CHANGE ORDER APPROVAL FORM

PROJECT: William Burgess Road Ext.

CHANGE ORDER NUMBER: 02

Add Inlet and Manhole Risers

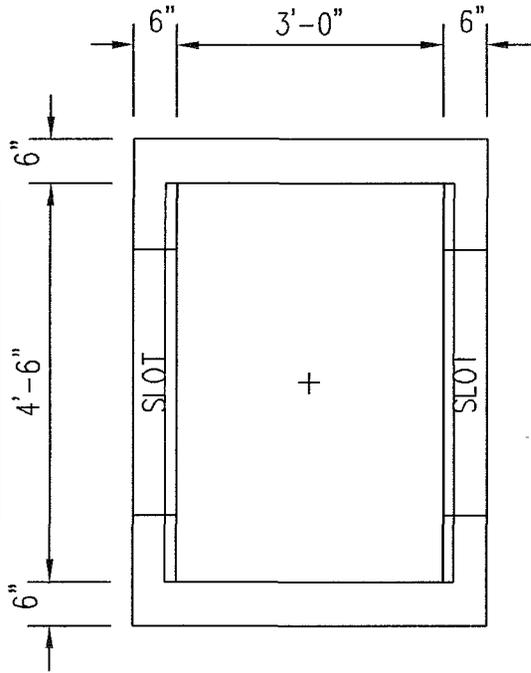
After discussing this w/ my precast supplier, a 9" riser with a 5"x 36" slot will not work. The riser will need to be a minimum of 18" for structural reasons.

What we are proposing to do is Build the risers 18" with a 5" x 36" slot cut in the riser 9" from the bottom. For this to work, we will have to cut down the existing box 9" then set the riser. This will make the bottom of the 5" slot match the existing top elevation of the box and raise the new top elevation to 9" above existing elevation.

The lead time on the risers will be 1 week, plus time to cut the existing box and set the new risers. Because this item is critical to grading the ditches and sidewalk we are asking for a 14 day time extension for this change if approved.

FDOT INDEX#232/201 E-INLET # S-07-RIS
1 EA

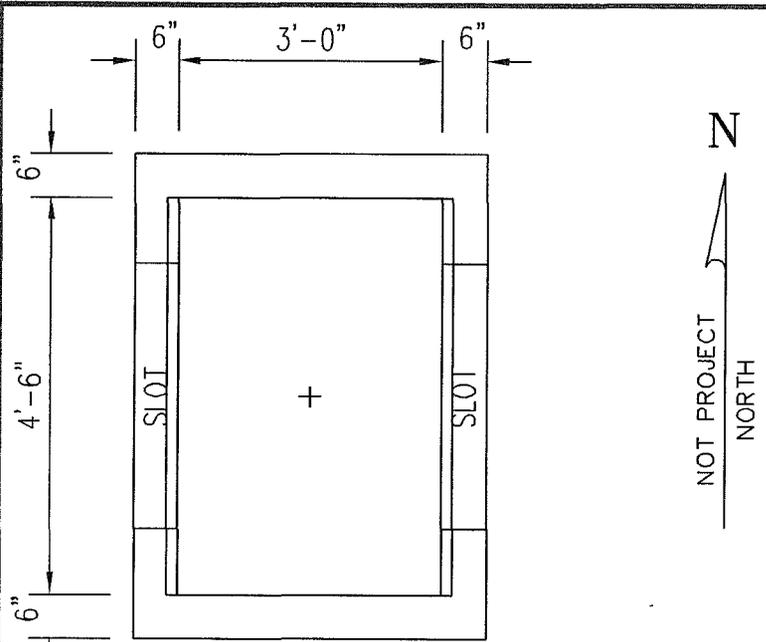
>
> Barry,
>
> Attached are shop drawings of the risers requested for William Burgess
> Boulevard. Please verify that they are correct and contact me to
> proceed with production.

RETURNED FOR CORRECTION
APPROVED AS SUBMITTED *X EY*
APPROVED AS NOTED
REJECTED-SEE REMARKS

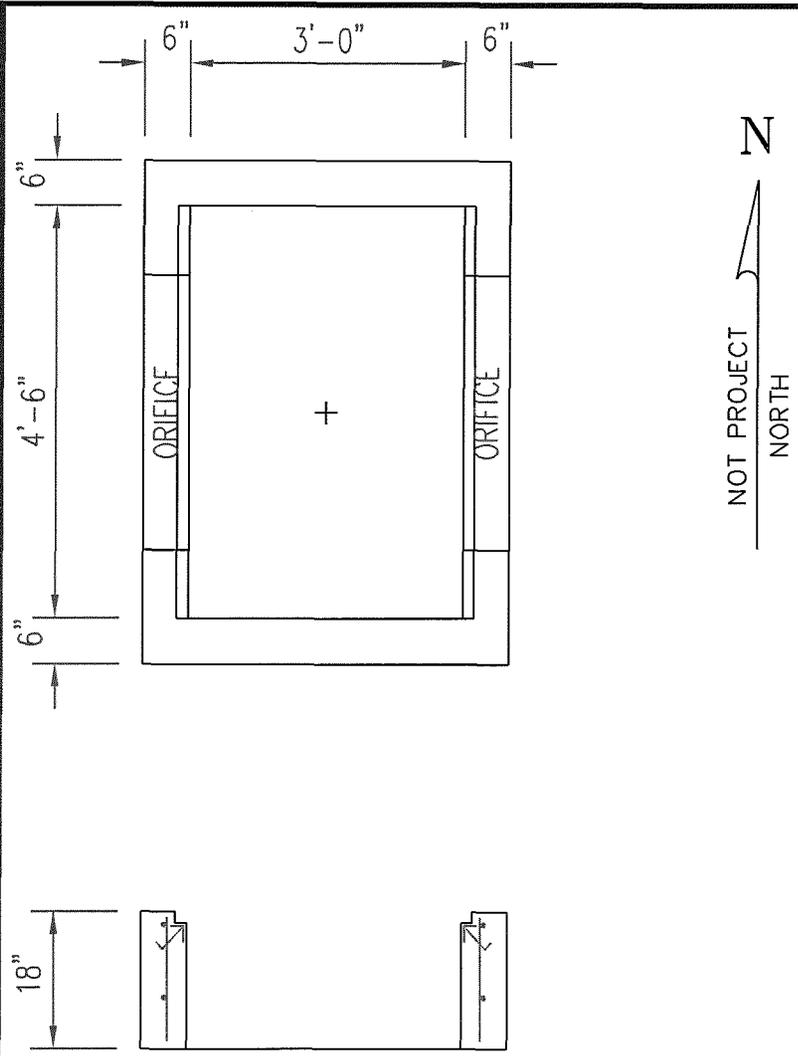
Nick, if you could issue new invert elevations for P-40 as the answer to the corresponding RFI that would be helpful to us.

Do you need anything from me on this or are you just lowering the pipe where the finished grade over the pipe (with the requisite 7" of cover) matches the edge of pavement grade at US 17?

Please make the invert at elevation 30.7 for pipe P-40. I showed a flat run and I believe you sloped the run, so the highest invert should be elevation 30.7.

48" DIA. STORM MANHOLE # S-03-RIS
1 EA

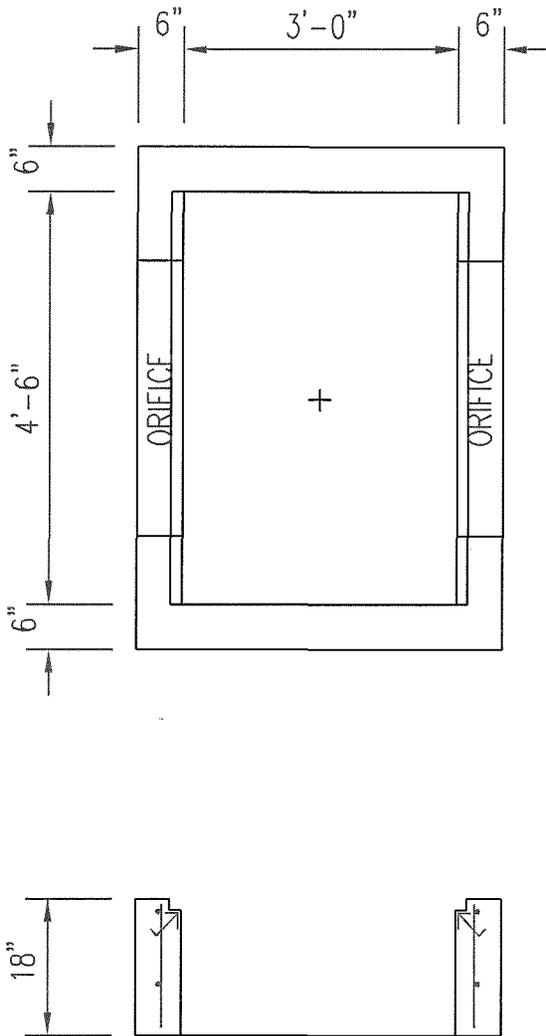
Evan, Robert and I were just looking at the items to be completed tomorrow and noticed that the manhole tops will need to be raised approximately 21-22 inches to be on grade with the sidewalk. Section 201, sheet 2 of 5 note 5 of the Standard index reads " Frames may be adjusted a MAXIMUM 12" height with brick or precast ASTM C478 grade rings" . These manhole structures are S-9A Sta 13+90 and S-3 Sta 22+80. Please advise. Thank you.
